TBT ENGINEERING CONSULTING GROUP

TBTE Ref No: 26-0120

Subject: City File Number: D02-02-24-0029
Update to Geotechnical Investigation
Concept Plan (April 2026)
2095 Dilworth Road
Ottawa, Ontario

CONCEPT PLAN

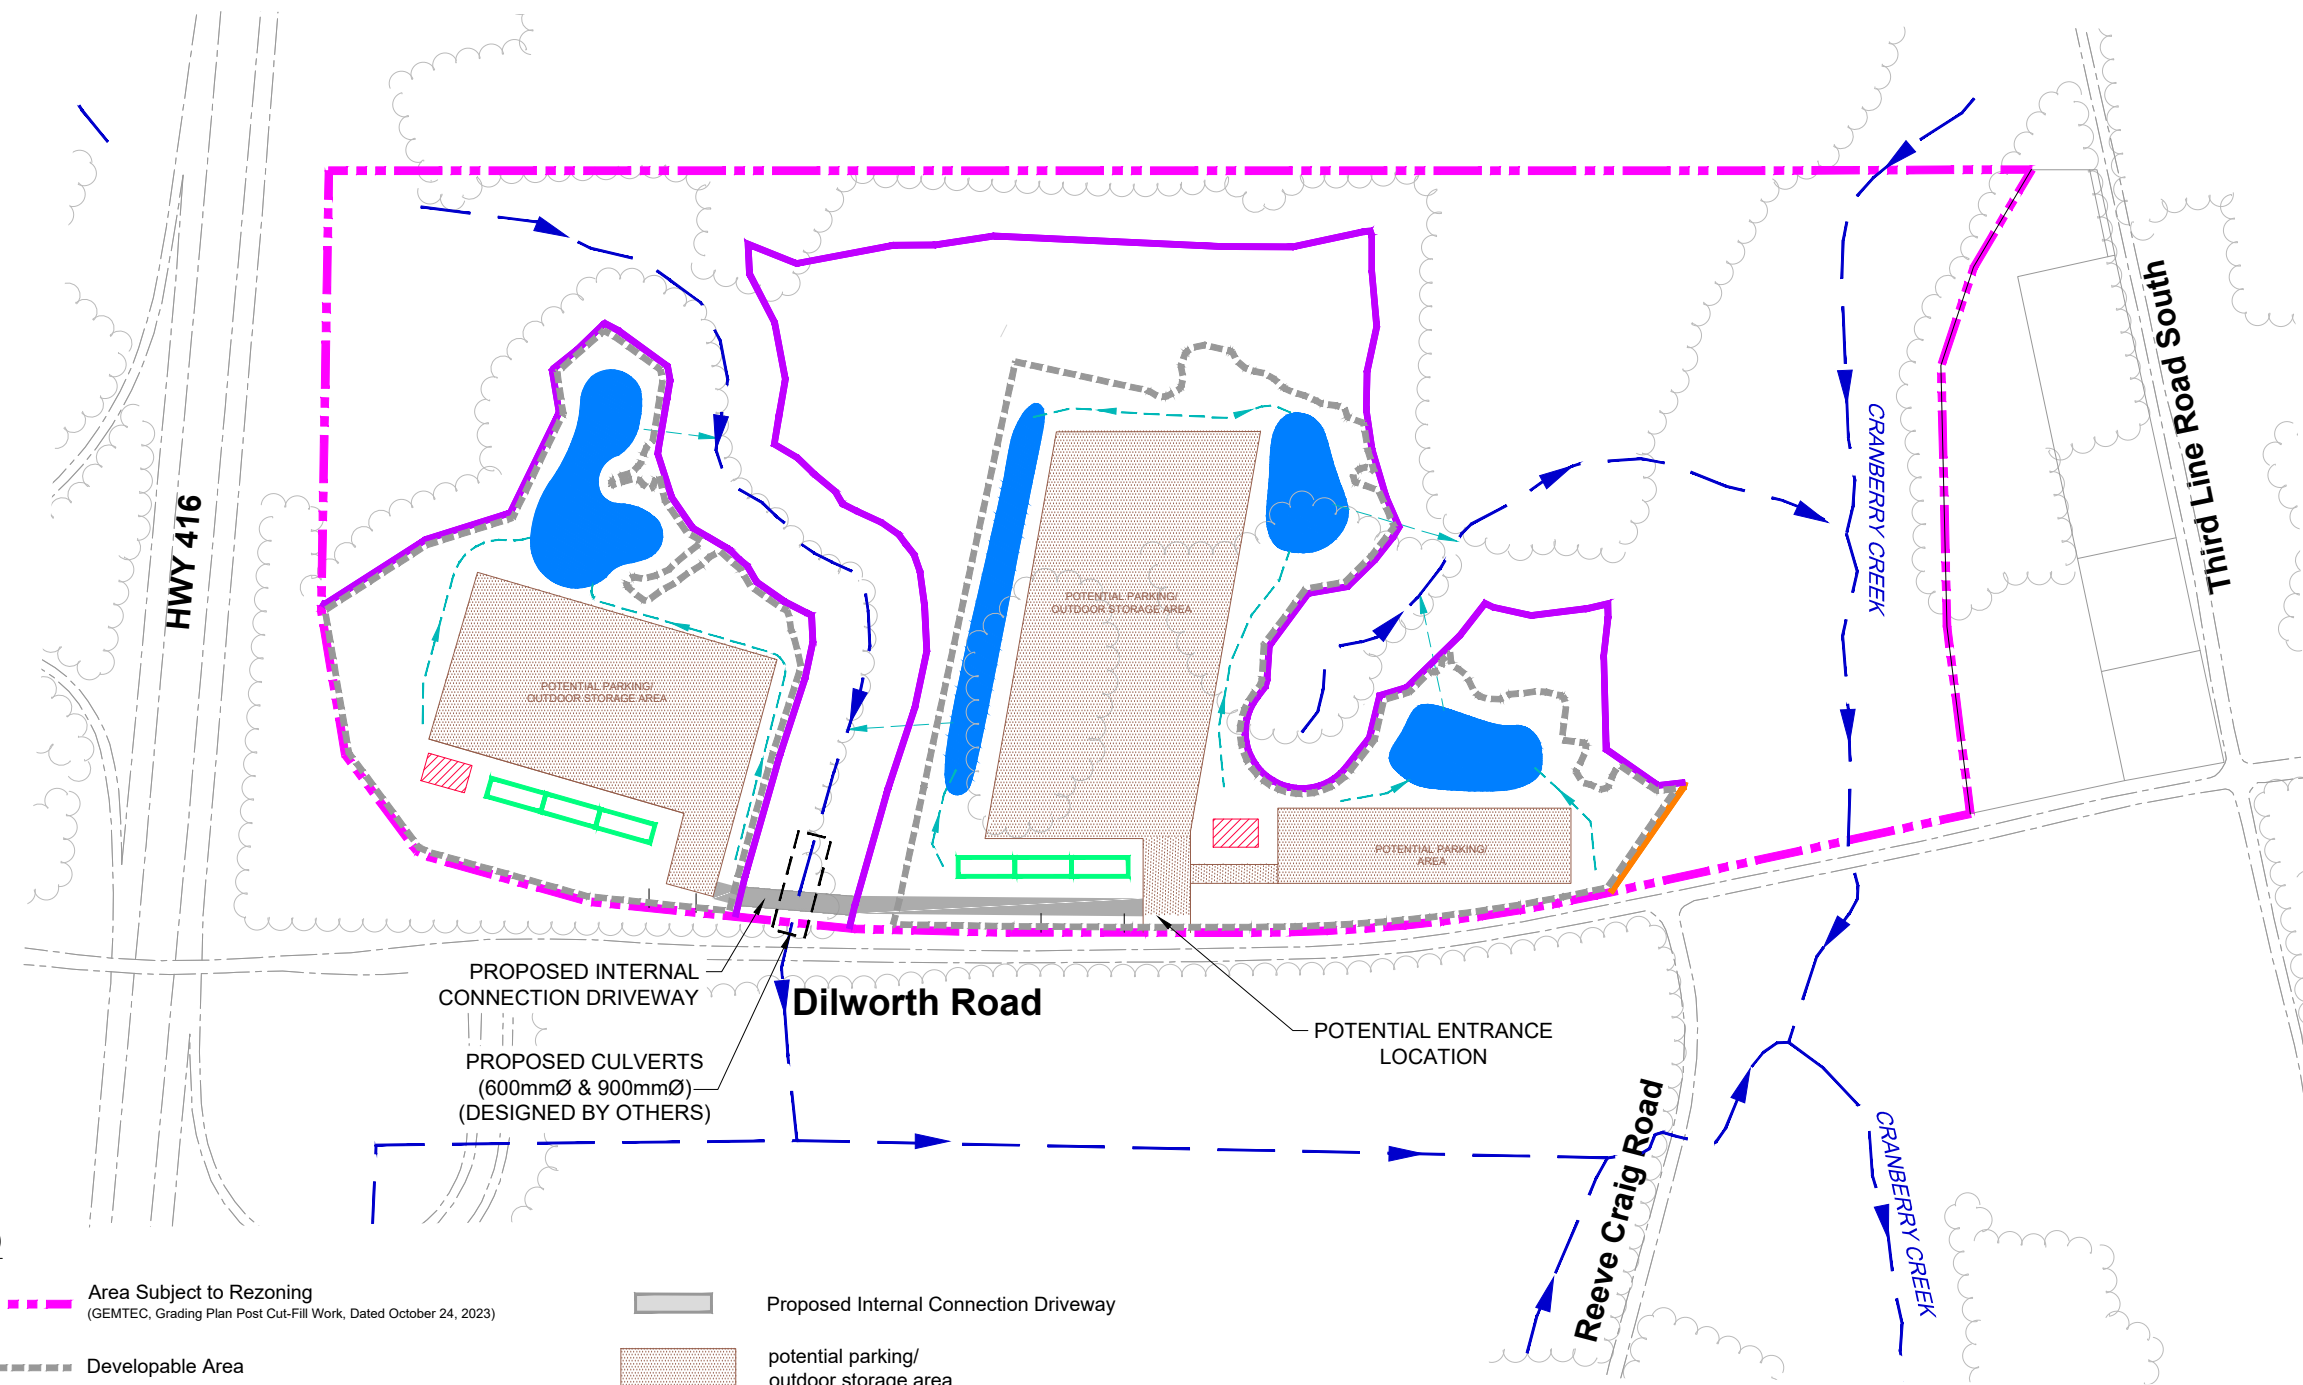
Section 6.8 stated that permanent drainage with a frost-free outlet will be required. With Options 1 and 2 and consequently deep foundations, it is not clear how the gravity flow to an outlet will be achieved and if its feasibility was contemplated. It is not clear if the proposed foundation drainage will impact the surrounding area clays (excessive settlement) and what mitigation measures might need to be implemented. Please discuss and provide related recommendations in the report. If the use of sump pumps is anticipated, please include it in the discussion, also noting that the sump pumps will need to be equipped with a back-up system with an alarm and independent power supply, per Ottawa Sewer Design Guidelines, Second Edition, October 2012, with bulletins.

Section 6.11.3 states that clay seals will be needed for any utility trenches. Does that also apply to the deep foundation drainage?

The current potential concept plan has only two buildings, located along the south limit of the Site. The buildings are intended to be single-storey slab-on-grade structures with no basement level. Buildings with no basement levels and a floor slab set at least 0.3 m above the exterior grade generally do not require perimeter drainage.

Buildings with no basement levels and a floor slab set at least 0.3 m above the exterior grade generally do not require perimeter drainage. Therefore, no perimeter drainage is anticipated for the buildings in the current potential concept plan.
